Modification to run CPU02CMI on 2.5MHz bus.

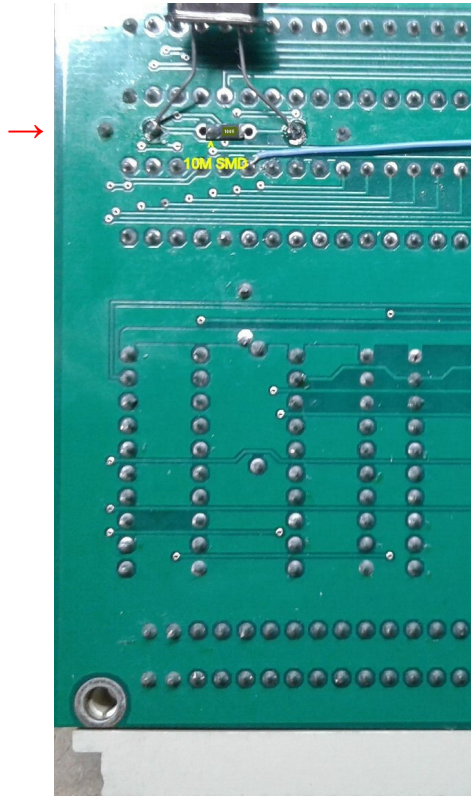
Replace xtal into 10MHz.

Replace C1 and C2 by 22 pF.

Place 10M 1206 smd between crystal pins.

↓ Only 10M 1206 smd between crystal pins.
